# HISTORIC AND DESIGN REVIEW COMMISSION

**HDRC CASE NO:** 2022-055  
**COMMON NAME:** 1014 N CHERRY  
**ADDRESS:** 1012 N CHERRY  
1014 N CHERRY  
**LEGAL DESCRIPTION:** NCB 512 BLK 25 LOT 6 HS  
NCB 512 BLK 25 LOT 5 & W 57 FT OF N 52.9 FT OF 10  
**ZONING:** RM-6, H  
**CITY COUNCIL DIST.:** 2  
**DISTRICT:** Dignowity Hill Historic District  
**APPLICANT:** Ricardo Turrubiates/Mint Development LLC  
**OWNER:** Delafield Investments, LLC  
**TYPE OF WORK:** Construction of six, 2-story residential structures  
**APPLICATION RECEIVED:** April 22, 2022  
**60-DAY REVIEW:** Not applicable due to City Council Emergency Orders  
**CASE MANAGER:** Edward Hall  
**REQUEST:**

The applicant is requesting conceptual approval to construct eight, 2-story residential structures on the vacant lots at 1012 and 1014 N Cherry Street, located within the Dignowity Hill Historic District.

# Height Exhibit

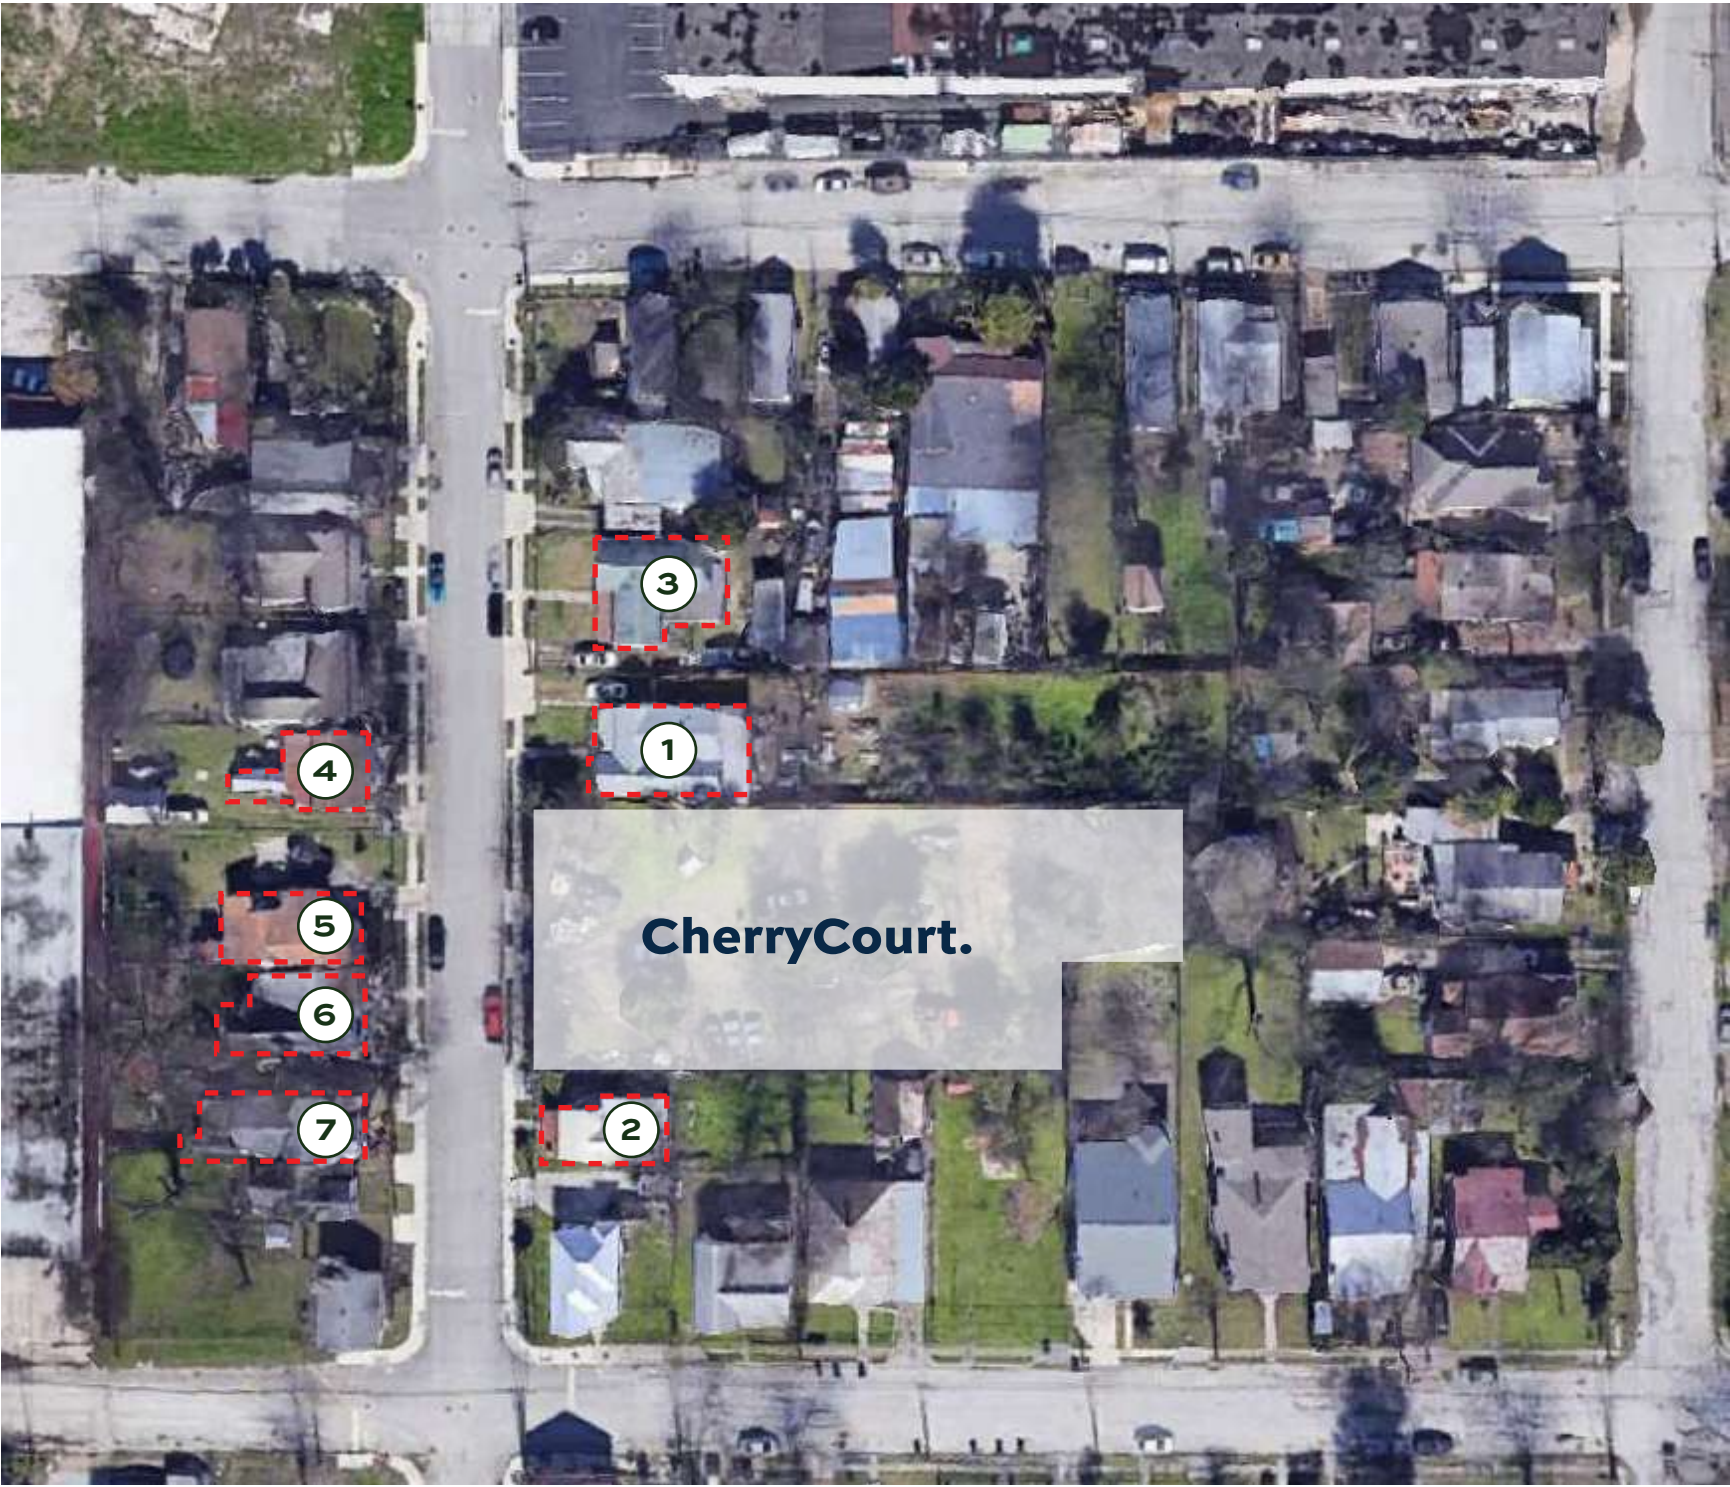
- f. **SCALE & MASS** – Per the Guidelines for New Construction 2.A.i., a height and massing similar to historic structures in the vicinity of the proposed new construction should be used. In residential districts, the height and scale of new construction should not exceed that of the majority of historic buildings by more than one-story. As noted in finding c, all of the existing, historic structures on this block feature one (1) story in height. Generally, staff finds the two story structures fronting N Cherry to be consistent with the Guidelines, as they feature one additional story in height over the existing, historic structures found on the block. However, within historic districts, the historic development pattern features rear structures with massing that is subordinate to that of the primary structure at the street. While the applicant has reduced the proposed development by two structures, staff finds the overall massing to be inconsistent with the Guidelines in regards to height and building footprint, as the historic development pattern throughout the district typically consists of rear structures featuring reduced massing and footprints in comparison to primary, street fronting structures. Additionally, staff finds that the applicant should submit a street elevation noting the proposed heights of new construction in relationship to existing, historic structures.

JF: Proposed massing seems to overwhelm the proposed massing of the adjacent one story historic structures (height and footprints).

JF: Modifications to roof forms may be appropriate – gable or clipped gable may work with the scale. Ceiling heights of buildings in relationship to historic one story structures feels overwhelming.

- iii. That the applicant decrease massing on site as noted in finding f. A reduction in building footprint or lowering of height to single story for some structures would be more appropriate.

## Exterior Material Palette

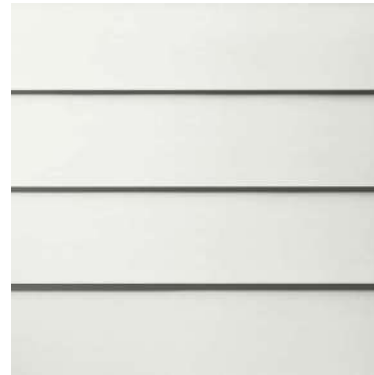
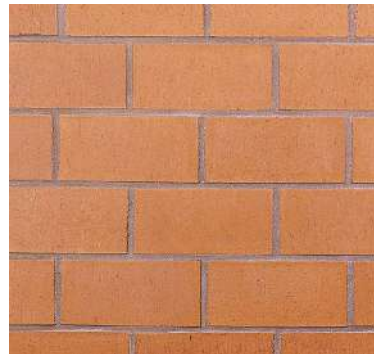
- k. **MATERIALS (Roofs and Secondary Materials)** – The applicant has proposed standing seam metal roofs and steel columns with wood elements. Generally, staff finds both of these to be appropriate. Staff finds that the proposed standing seam metal roofs should feature panels that are 18 to 21 inches wide, seams that are 1 to 2 inches in height, a crimped ridge seam or a low profile ridge cap and a standard galvalume finish. If a ridge cap is proposed, it must be submitted for review and approval.

- l. **MATERIALS (Windows)** – The applicant has proposed to install aluminum windows in a bronze finish. Window product specifications have not been submitted at this time. Staff finds that wood or aluminum clad wood windows that are consistent with staff standard specifications are to be installed. A window featuring alternative materials may be appropriate, provided it meets staff's standards, as noted in the applicable citations.

- v. That the proposed standing seam metal roofs should feature panels that are 18 to 21 inches wide, seams that are 1 to 2 inches in height, a crimped ridge seam or a low profile ridge cap and a standard galvalume finish. If a ridge cap is proposed, it must be submitted for review and approval.

- vi. That wood or aluminum clad wood windows be installed as noted in finding l and in the applicable citations. An aluminum window may be appropriate provided that it is consistent with staff's standards for windows in new construction.
